Santos QNT Pty Ltd (Santos) is the operator of exploration permits (EP) 161, located approximately 350 km south-east of Katherine in the Northern Territory (NT). On 6 June 2019, Santos received formal advice that the Environmental Management Plan: *McArthur Basin Civil and Seismic Program* (DENR EMP assessment document reference: NTEPA2019/0032-007~0005) was approved.

In accordance with Regulation 22 of Petroleum (Environment) Regulations, Santos proposes to modify the regulated activity for the above EMPs and is writing to the Minister to give notice and specify details of the proposed modification. The modification of the regulated activity relates to:

1. A modification of the lease pad layout design at the Inacumba 1/1H location
2. The installation and filling of tanks with bore water at the Tanumbirini 1/2H location and the Inacumba 1/1H location.

Lease pad layout design at the Inacumba 1/1H location

FIGURE 3-6

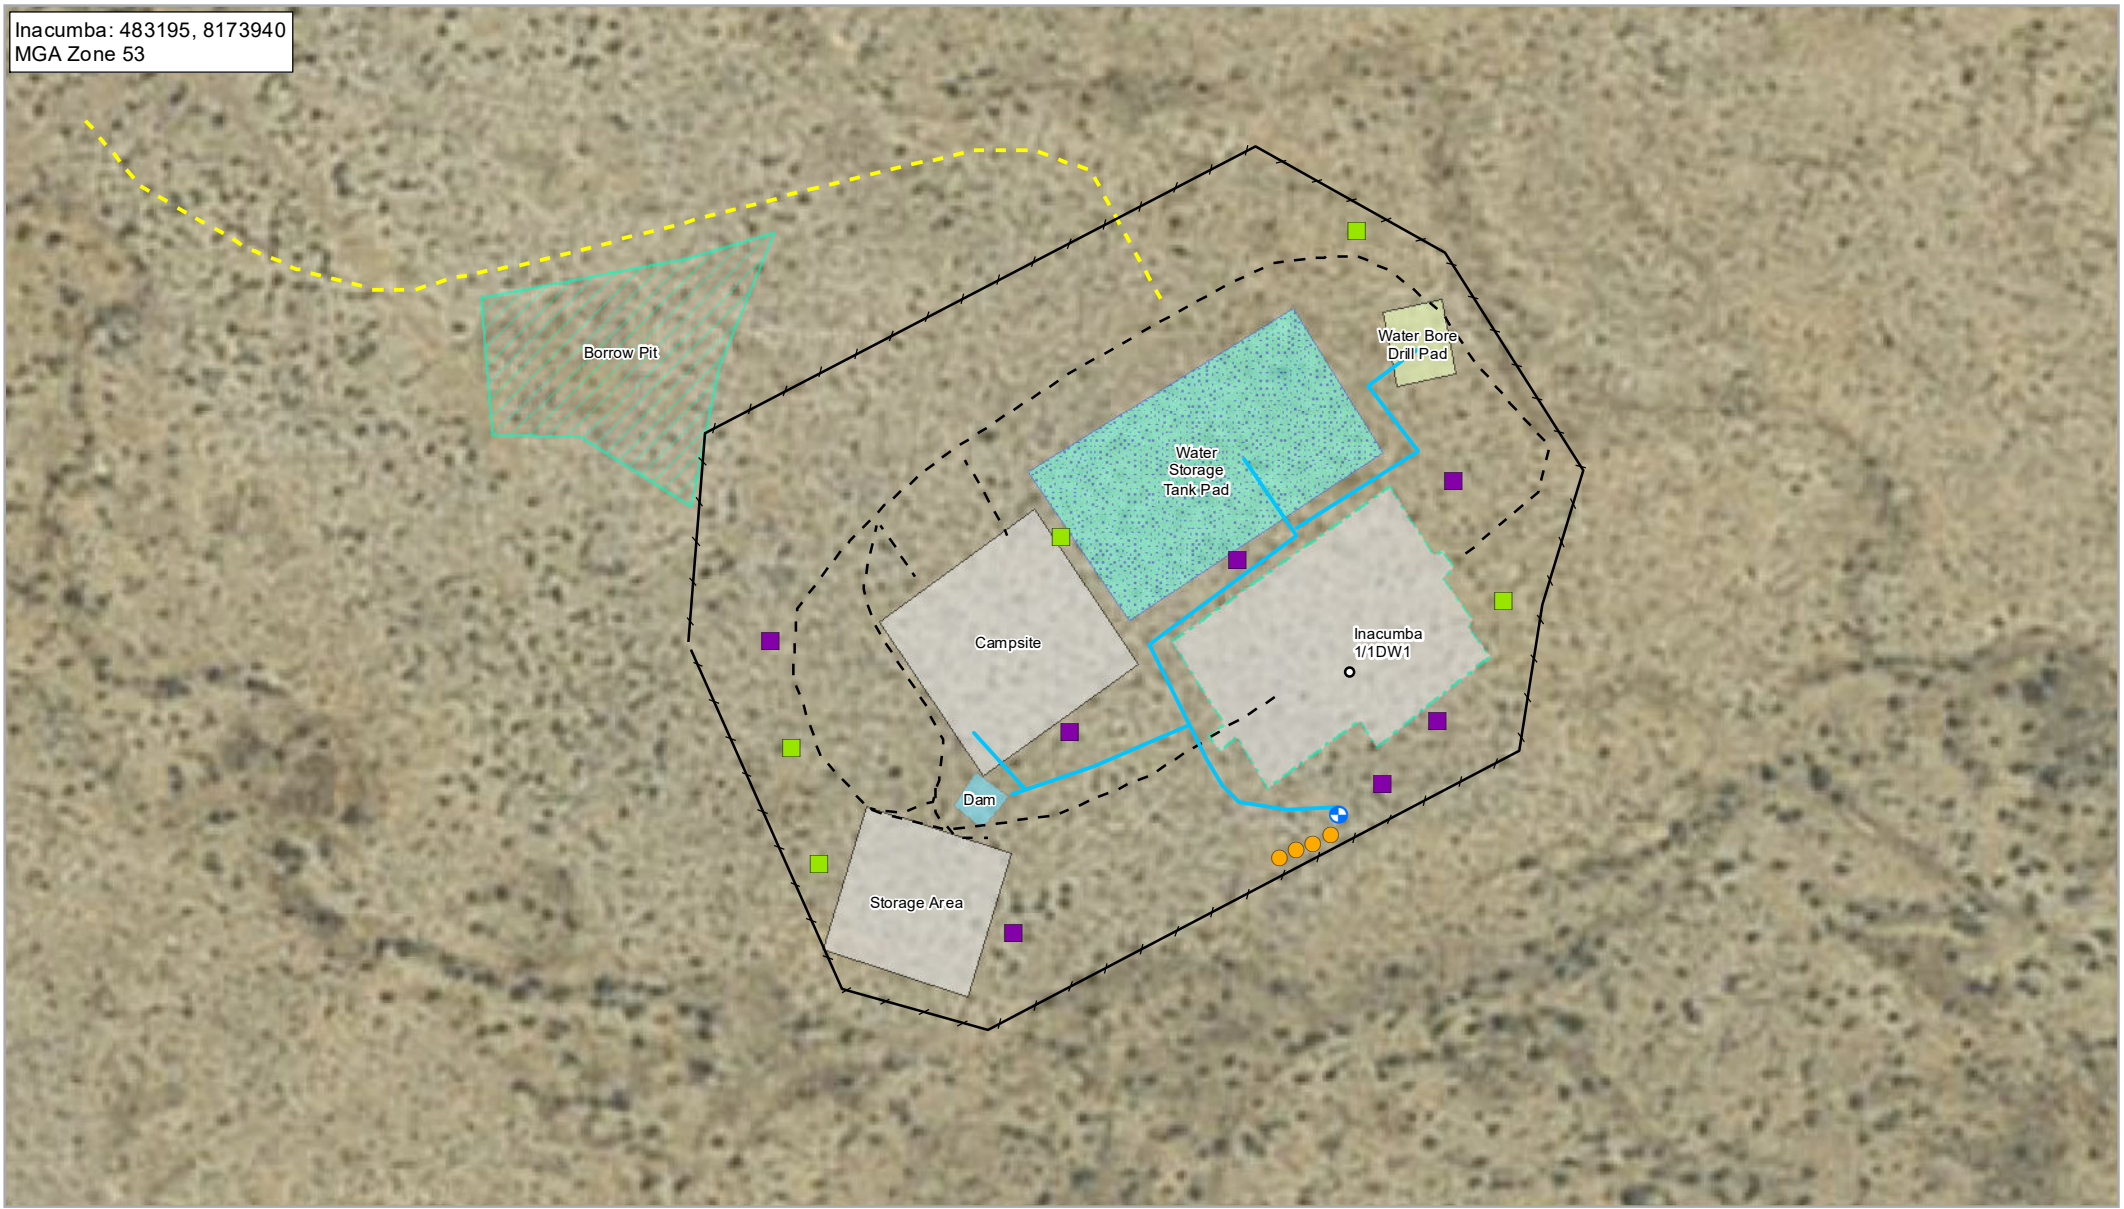
The lease pad layout design at the Inacumba 1/1H location has been modified as a result of learnings associated with the recently constructed Dukas-1 exploration well lease pad. The new proposed lease layout is provided in Figure 1 below. Major elements of the reconfiguration include combining the two separate tank pads and moving them from the east of the well site to the north and moving the laydown area from the north to the south-west. Existing infrastructure (water bore infrastructure) and the proposed petroleum well location and well site infrastructure (sumps etc.) are unchanged.

Figure 4-5. Map showing location of riparian and drainage line vegetation within Inacumba-1 survey area

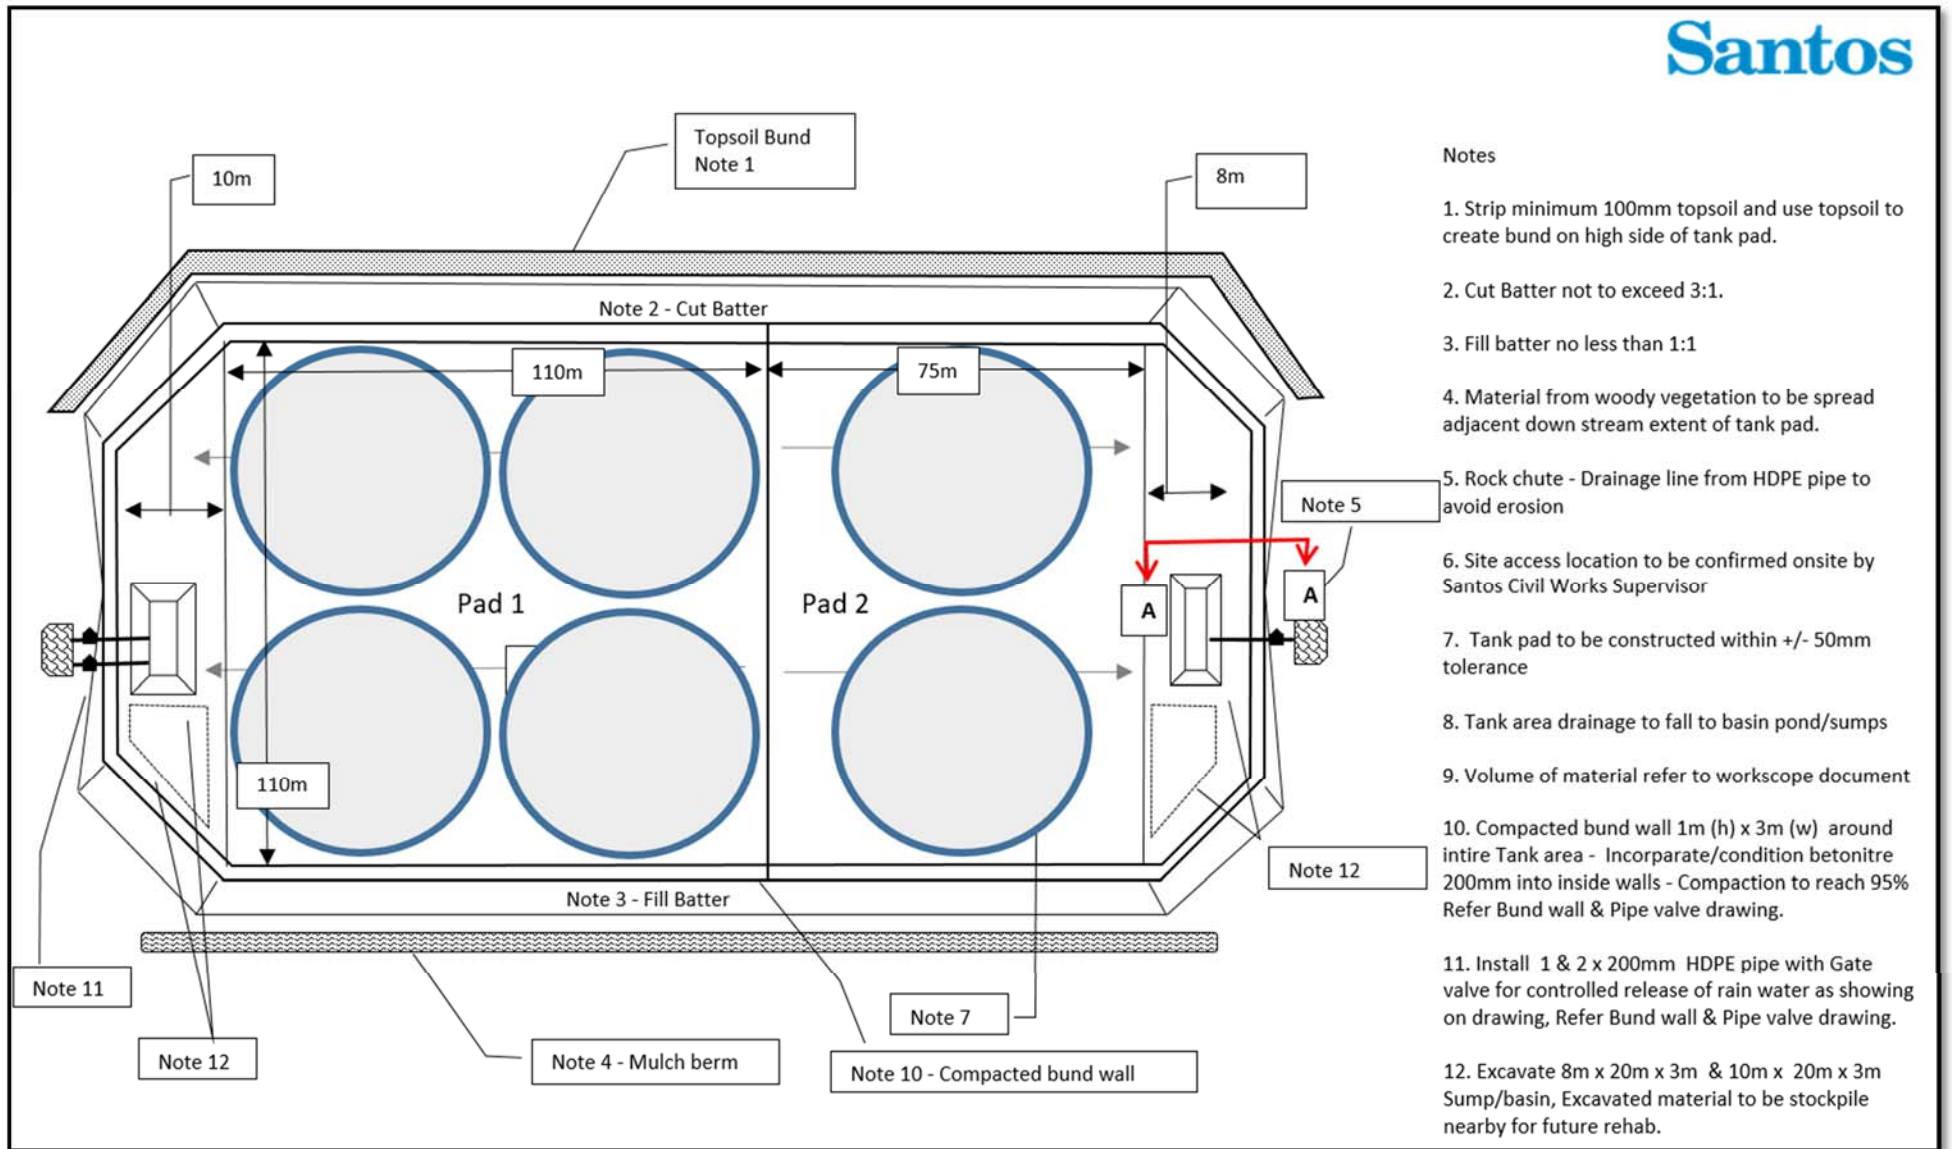
The modification has not caused a new environmental impact or environmental risk and has not resulted in an increase in an existing environmental impact or environmental risk. The size of the fire control area associated with the Inacumba 1/1H exploration lease pad will not increase. The quantum of vegetation clearing required will not increase and vegetation clearing within the areas mapped as "drainage line vegetation" will be reduced as a result of the reconfiguration (see Attachment 1).

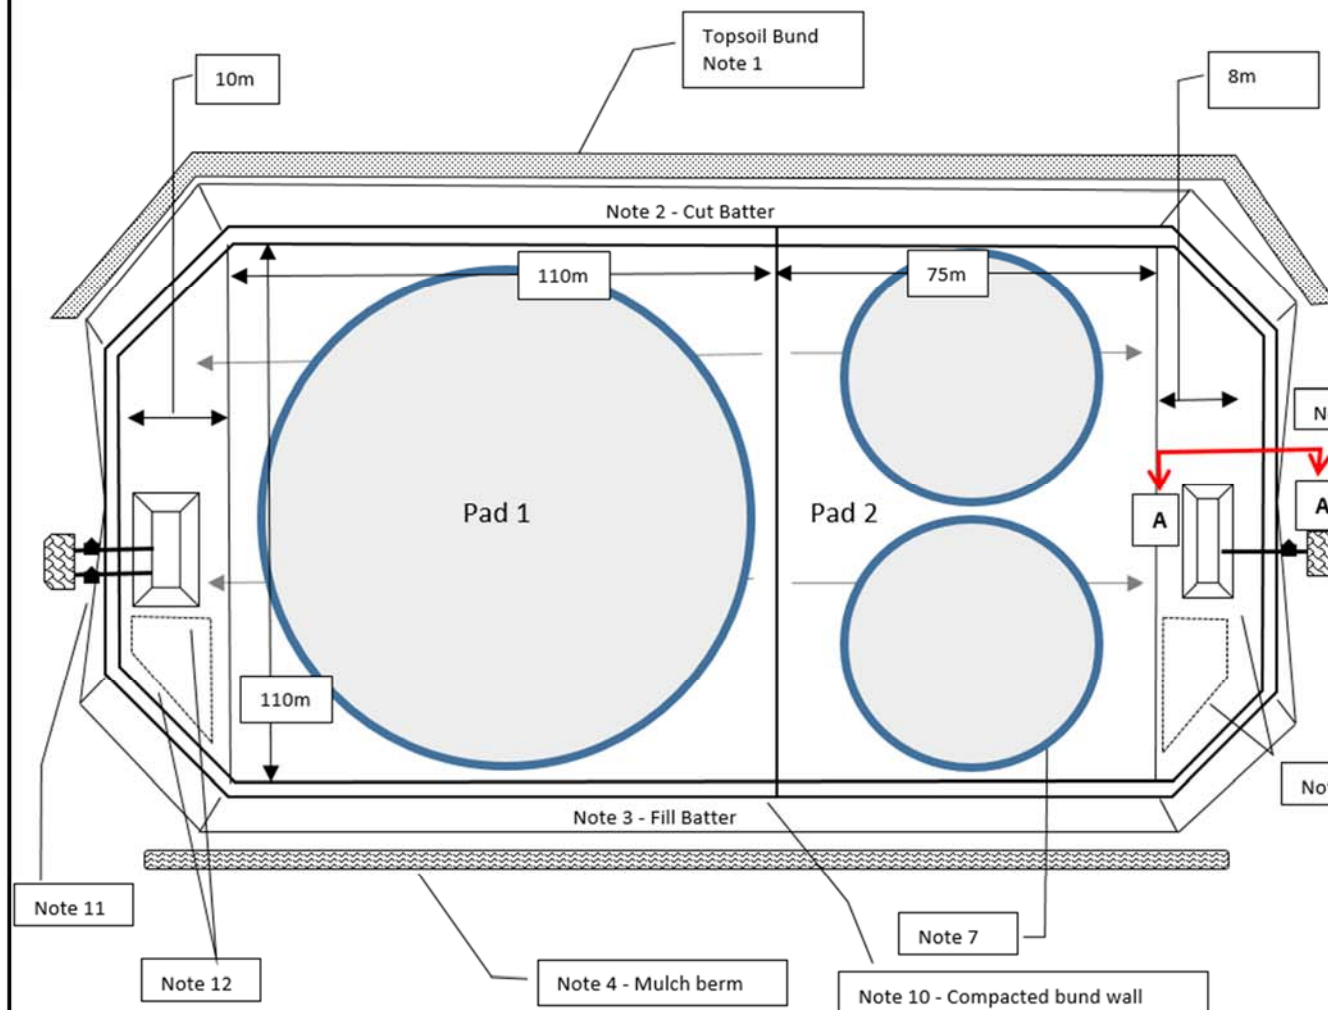
The modification to install and fill tanks with bore water at the Tanumbirini 1/2H location and the Inacumba 1/1H location is important to secure the water supply requirements for the all stages of the 2019 exploration project. Water supply has been lower than anticipated at all monitoring bores. To date all water bores that have been drilled in 2018 and 2019 have either produced water at a lower rate than expected or produced no water at all (i.e. first water bore at the Inacumba South location). We interpret that variability in permeability that is intrinsic to limestone aquifers is the primary cause for the lower than expected water flow results hence, there is no change to environmental risk or assumptions regarding the sustainability of the proposed water extraction. A reliable water supply is critical for all stages of the 2019 exploration project. The tank pad layout plans for the two potential configurations are provided in Attachment 2 and the Tank specification is provided in Attachment 3

- Ponds will be filled to a maximum of 30 cm freeboard (for bore water)
- Leak detection measures will be in place
- Tanks will be double lined
- Volumes pumped into each of the tanks will be measured and recorded, including estimated evaporation rates
- Tanks will be monitored via a fluid management crew
- Tanks pad will be bunded with low point sumps at either end to be able to capture fluid (see Attachment D).
